Supporting explanations for P802.3ds draft D1.0 comments

Eric Bernier, Limin Geng (Huawei)

Comments against P802.3ds draft D1.0

Consideration on OMA_{max}

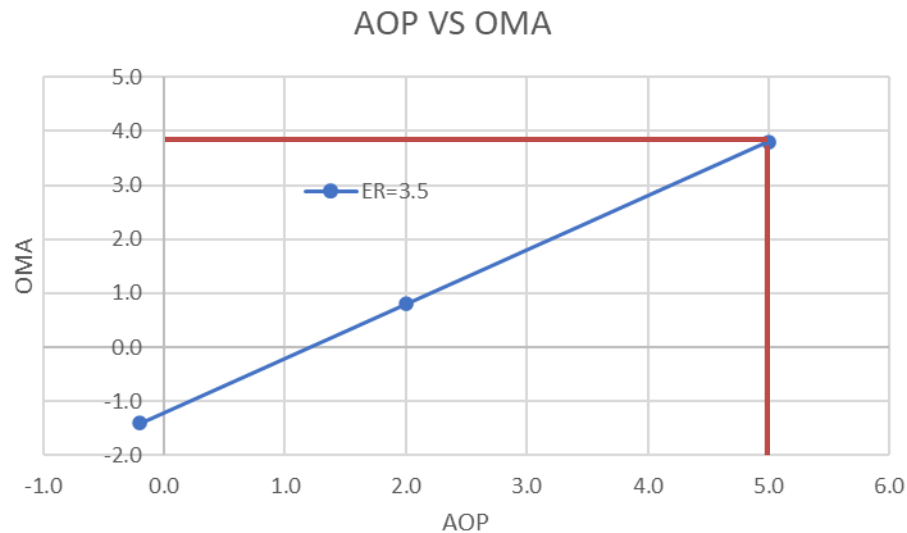
- Compared with 802.3df, 802.3ds Baseline AOP_{max} is increased by 1 dB, but OMA_{max} remains unchanged.
- Calculated based on AOP and OMA conversion formula, OMA is 3.8dBm corresponding to AOP 5dBm, which is exceed the OMA max spec 3.5dBm
 - Propose setting Tx OMA_{max} specification as 4dBm
